**EPA Superfund
Record of Decision Amendment:**

**APACHE POWDER CO.
EPA ID: AZD008399263
OU 01
SAINT DAVID, AZ
09/20/2005**

**AMENDMENT TO RECORD OF DECISION
APACHE POWDER SUPERFUND SITE
Benson, Arizona
September 2005**

Figure 3. Groundwater Contamination in Southern Area

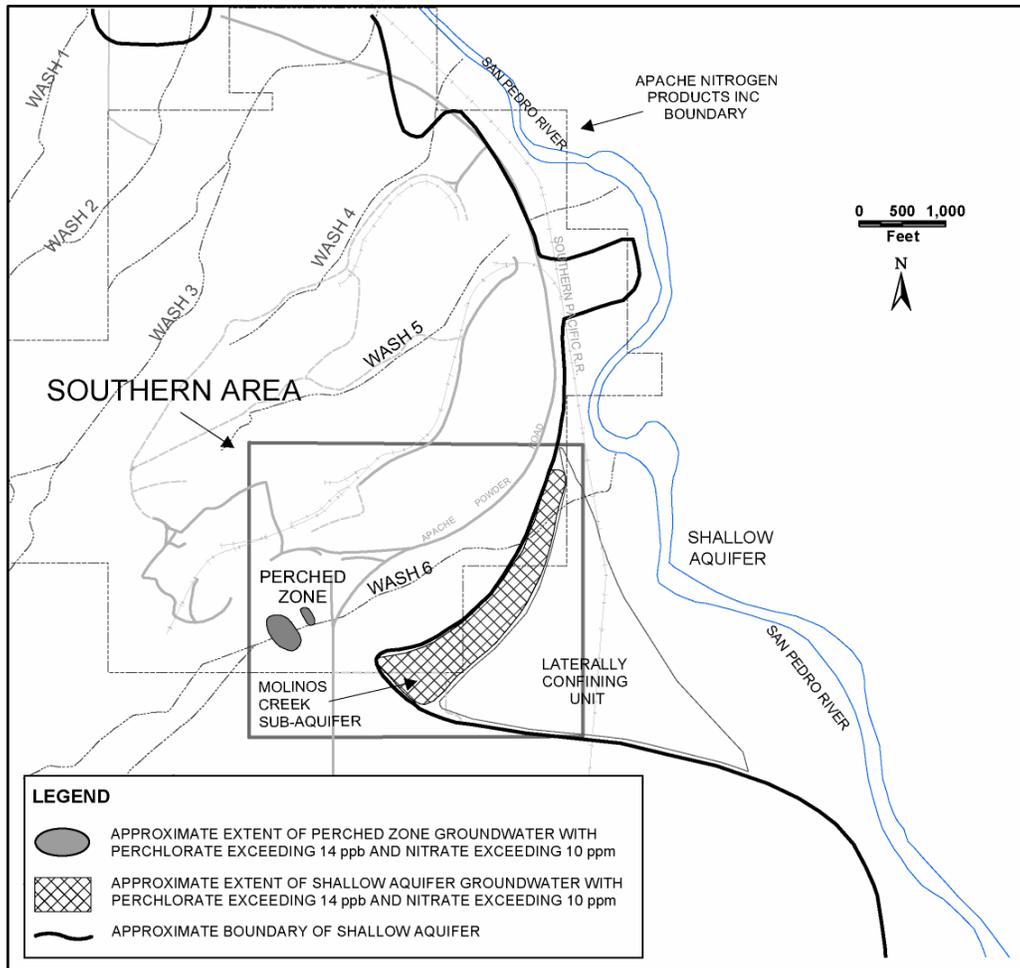
As a result of these studies, EPA has determined that Monitored Natural Attenuation (MNA) will address both nitrate and perchlorate and is the more appropriate remedy for the Southern Area.

Figure 5. Northern Area Remediation System (NARS)

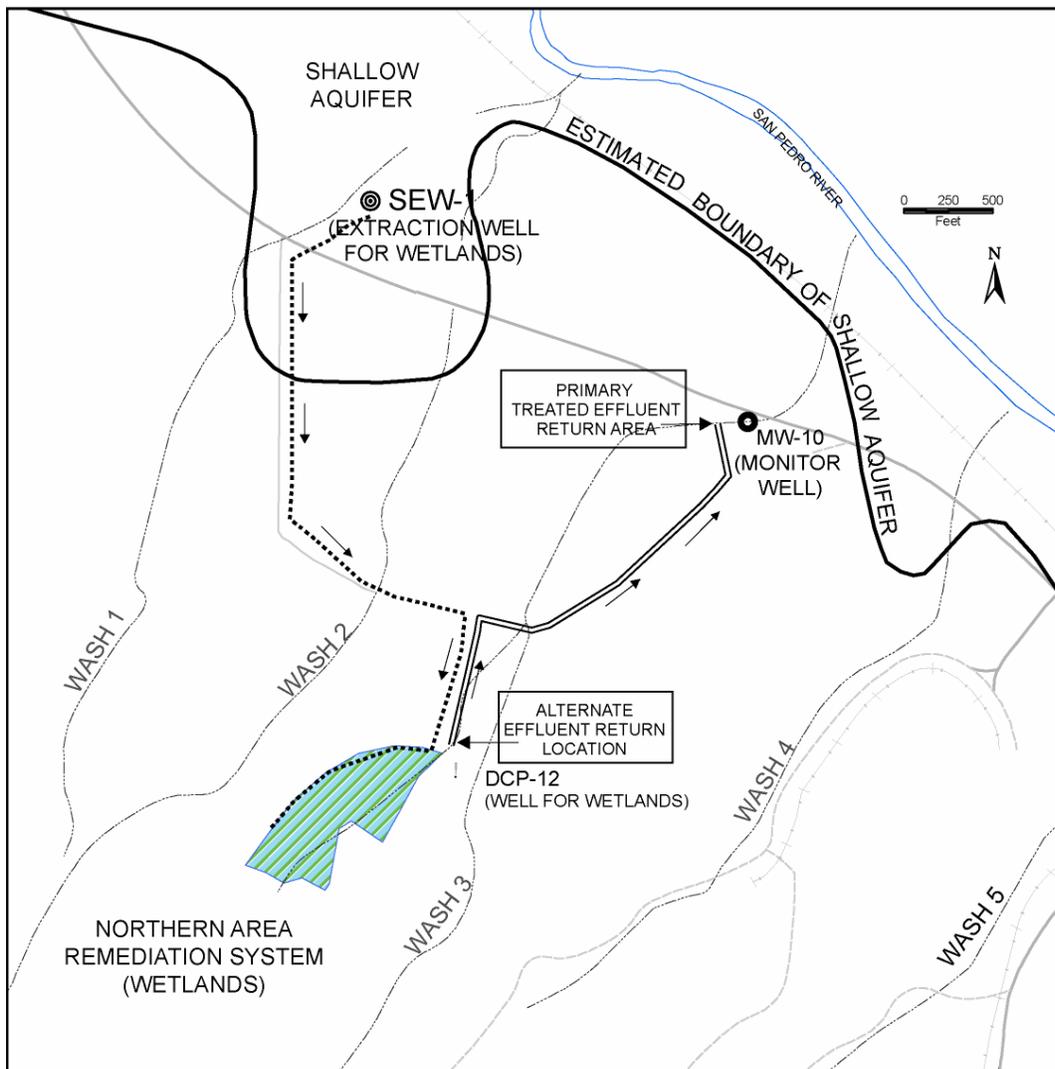
concerns regarding coliform (e-coli) standards for the San Pedro River, EPA directed ANP to discharge to an alternate discharge point in Wash 3, located approximately one mile away from the San Pedro River. The e-coli issue has now been resolved and unlike prior years, the wetlands are now treating the nitrate consistently to below 10 ppm. As of May 2005, the NARS treated effluent was below 5 ppm nitrate. The NARS-treated effluent is now being discharged at the primary discharge location in Wash 3, in close proximity to the shallow aquifer and the San Pedro River (see Figure 5).

The 1994 ROD required the treated effluent from the wetlands to meet a nitrate cleanup standard of 10 ppm when it was discharged into the shallow aquifer. However, the ROD and the 1997 ESD modifications to the wetlands remedy did not include any provisions if the effluent did not meet the 10 ppm standard nor allow for operational flexibility. In this action, EPA is amending the remedy to allow some operation flexibility to the NARS, including provisions for an alternate discharge point as follows:

- Discharges of treated effluent at the primary discharge location must be at or below 10 ppm nitrate at all times.
- To allow for operational flexibility and interruptions to treatment due to unforeseen causes, effluent may be discharged at the secondary discharge location up to 20 percent of the time (see Figure 5). Discharges at the secondary discharge location may exceed 10 ppm nitrate in accordance with the State's tributary rule (Arizona Administrative Code (AAC) R18-11-105(1))
- Discharges of e-coli from the NARS are exempt from meeting total counts of coliform because the e-coli is not a result of humans but from the use and visitation of wildlife to the wetlands.

Figure 6. Location of *Inactive* and *Formerly Active* Ponds

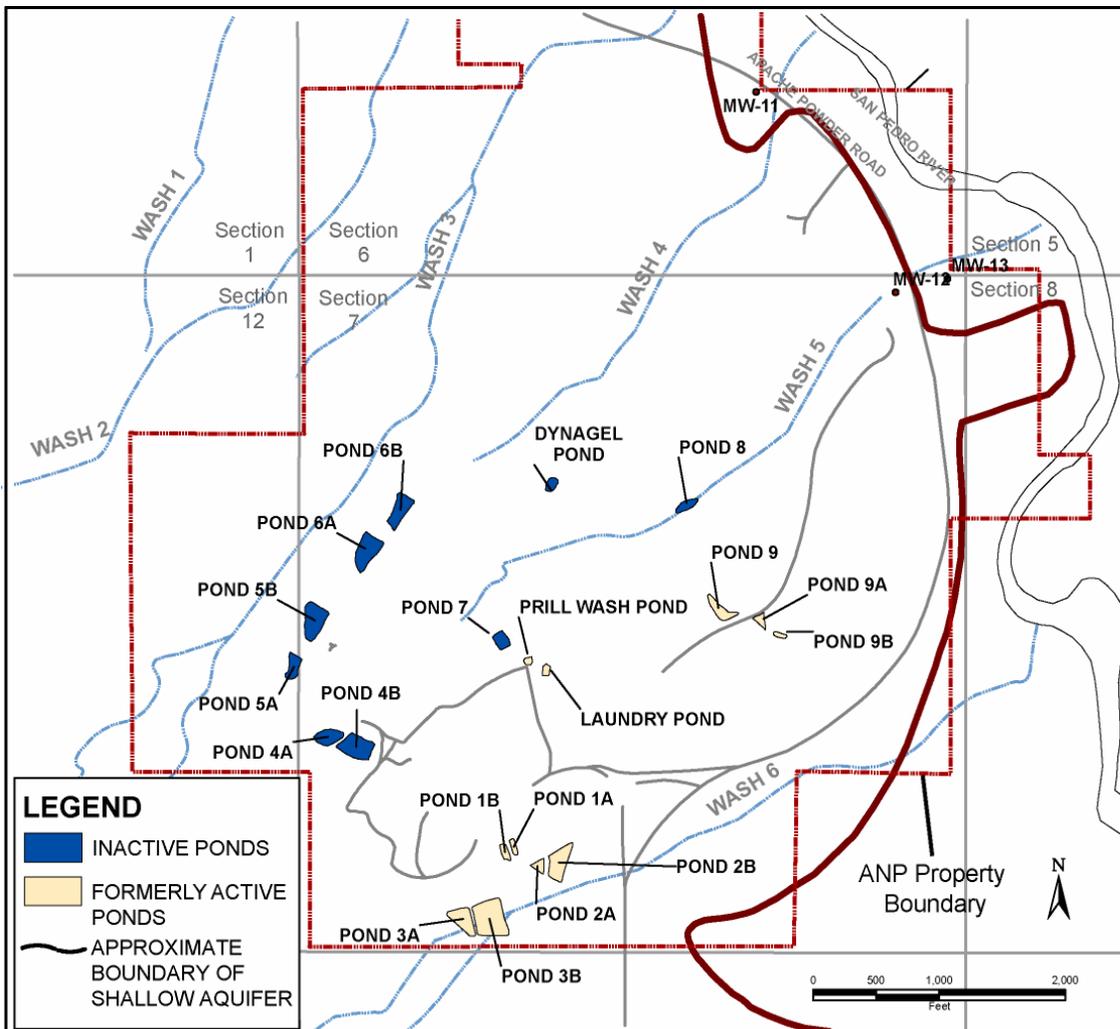
- During the early 1990s, ANP conducted an investigation of the contaminated soils areas at the Site. EPA and ADEQ identified several areas of soil contamination to be addressed, including contaminated evaporation ponds (see Figure 6).

EPA's selected revised remedy for cleanup of the Contaminated Soils and Sediments in Ponds (see Figure 8) at the Apache Powder Superfund Site is a combination of Alternative 4 (Containment with a Native Soil Cap) and Alternative 2 (Institutional Controls). This is a change from the 1994 ROD which selected use of containment with a clay cap for the residual soil contamination to be left on the ANP facility. These alternatives were compared against EPA's nine criteria in Figure 2. Alternatives 3 (Containment with a Clay Cap) and 4 (Containment with a Native Soil Cap) are both effective and implementable. However, because the primary exposure pathway is inhalation or ingestion, both types of caps are equally protective and a native soil cap is significantly lower in cost. EPA does not consider the No Action Alternative 1 effective or protective for the contaminated soils in ponds.
